KMR.CDD.MmQ.1916.03

ORDERS UNDER SECTION 96 (2) OF ACT, III OF 1901

With reference to his application, dated 2nd May 1916.
 Messrs Nance & Kanyo sons of Kaji is informed
 that the plan submitted by him for building rooms on 3rd floor
 of building on plot No. 85, Survey Sheet C1,
 situate in Kasim Street, Machi Meani
 Quarter, is approved, and permission to build in accordance therewith is
 Granted. The building to be erected subject to the Bye-laws and Rules of the
 Municipality.

PLAN SHOWING PROPOSED ROOMS ON 3RD FLOOR ON HOUSE
ON PLOT NO 85 SHEET C.1 MUCHEE MEANEE QR
SCALE: 8FT=1"

PLAN OF 3RD FLOOR
(PROPOSED)

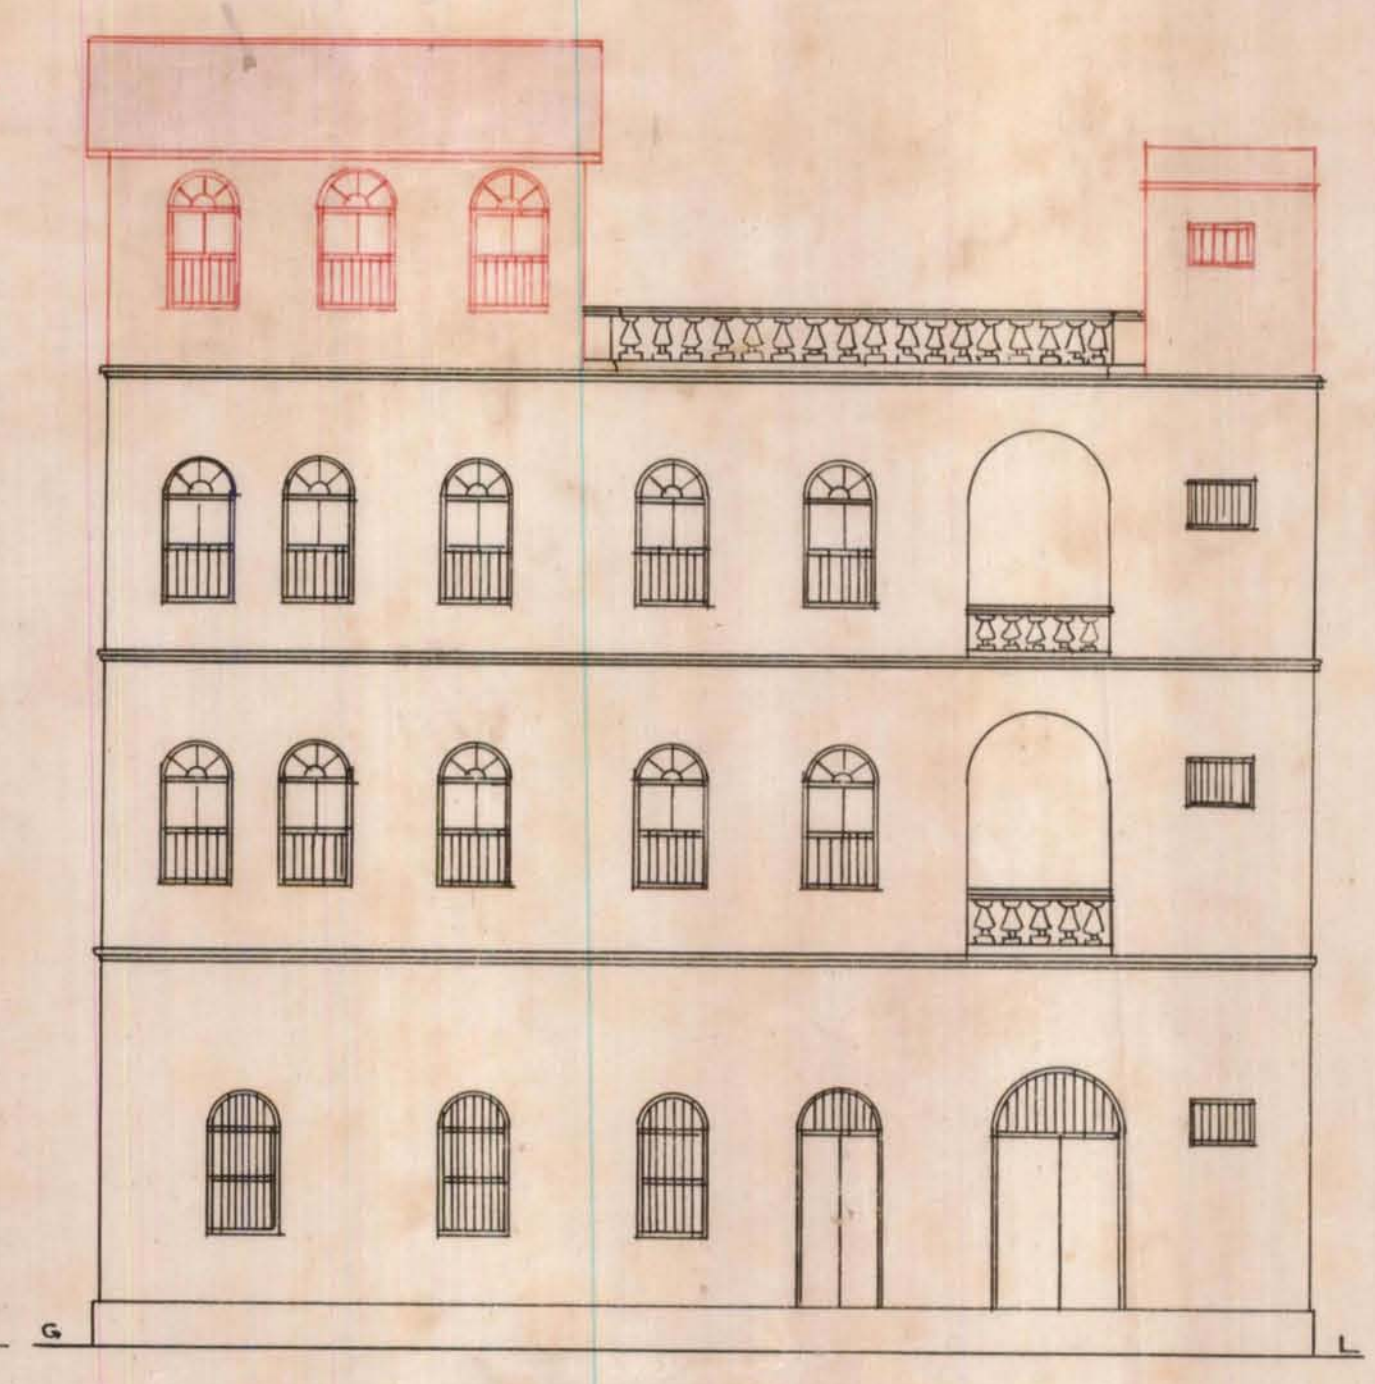
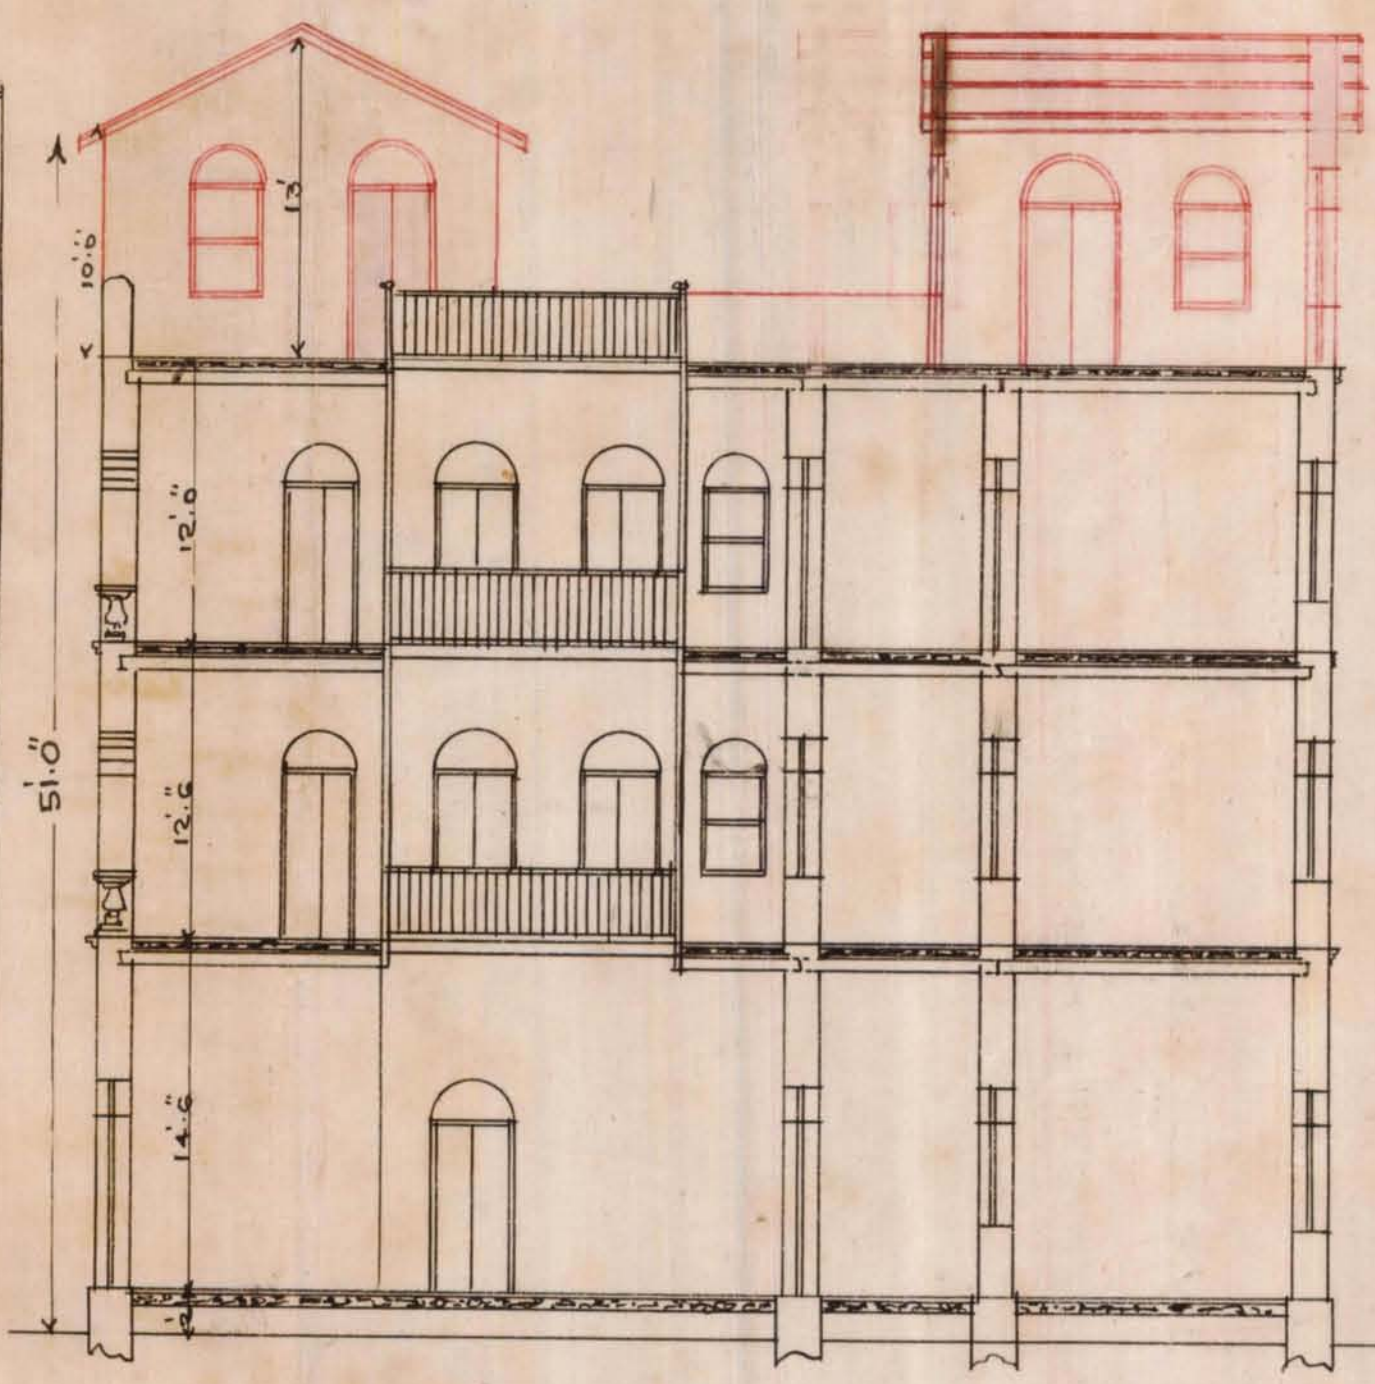
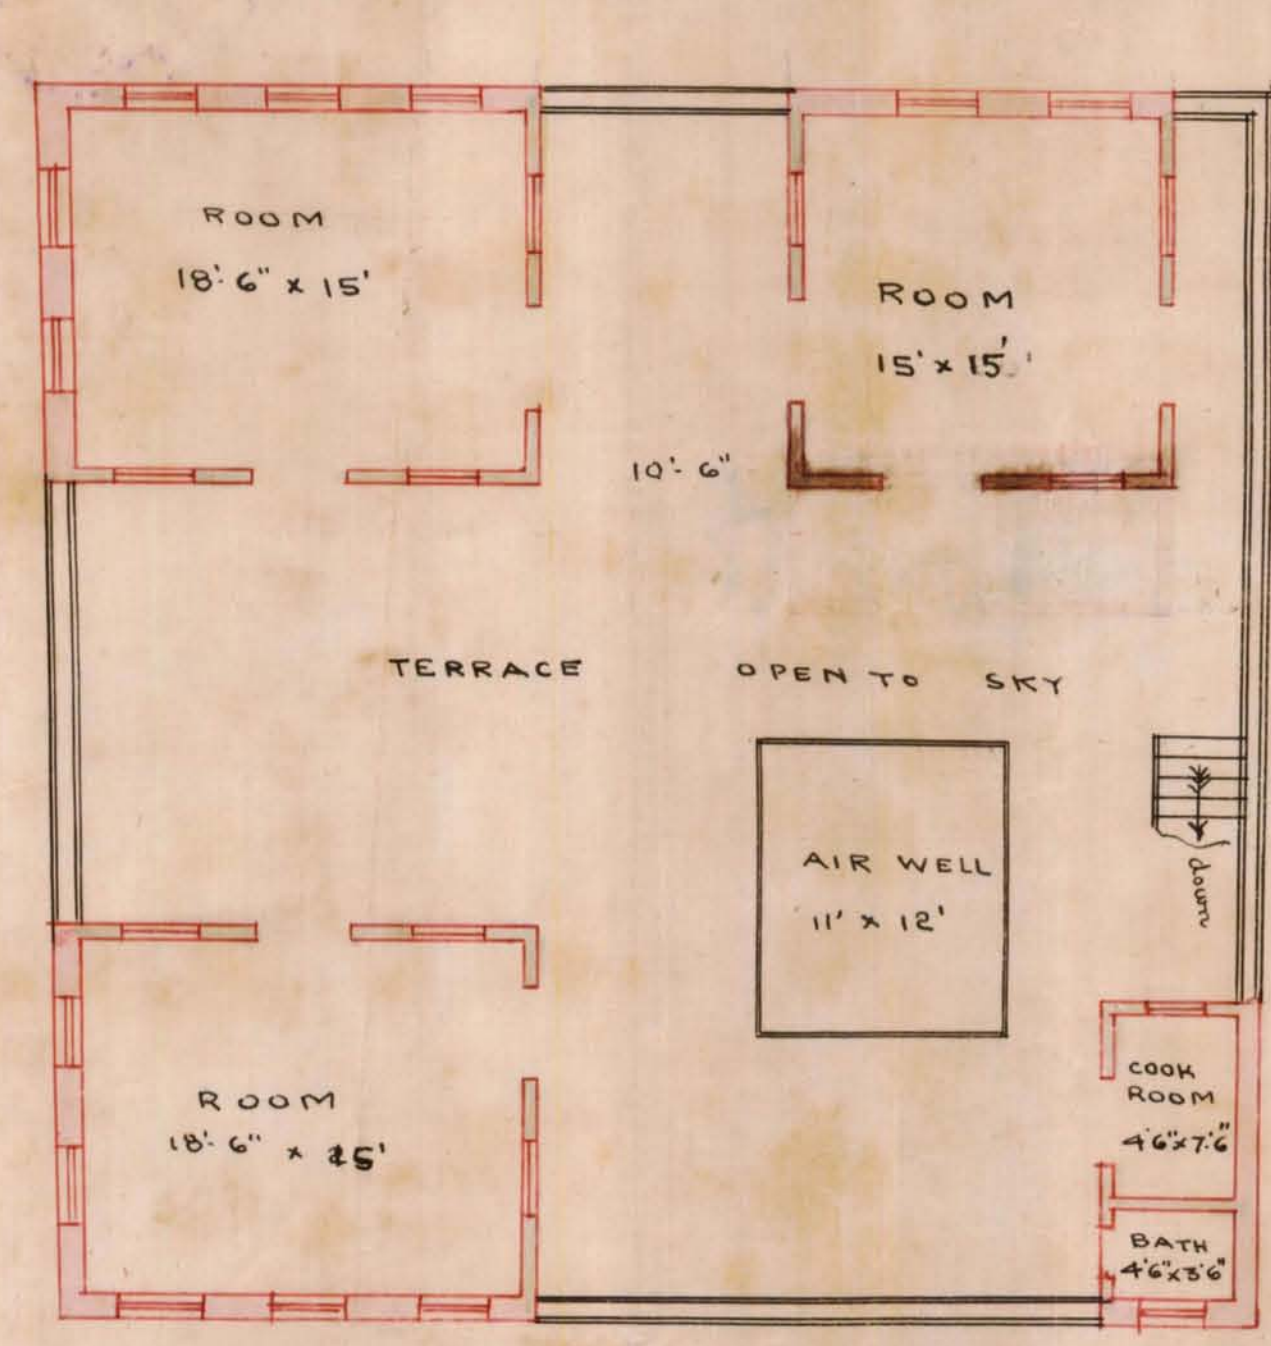
With reference to their application dated 2nd current with plans for building 3rd floor on Plot No: 85-C-1 Machi Meahi Quarter Messrs Nanco & Kanji sons of Haji are informed that the plan as submitted cannot be approved.

If he will call at this Office a suggested alteration will be pointed out to him and if the plans are so amended they will receive further consideration.

With ref: to their application of 2nd current with plans for Building 3rd floor a plot no 85 C-1 Mach Mean. On Mem. Nanoo + Kanyee S/o Itaji are informed that he has shown a room 20' x 15' To the West which should be equal made 15' x 15' so as to be in the same line with the one to the East as shown in red pencil on the plan herewith returned for amendment accordingly.

With reference to your No E. 4117 of $\frac{22}{23}$ rd
May 1916. I beg to resubmit the plans
for building 3rd floor to house on plot No 85
Sheet C. 1, Muchi Meance Quarter duly
amended as shown personally.

With reference
to this they report that
there seems now no
objection to grant pass.
as the person has been
amended accordingly.
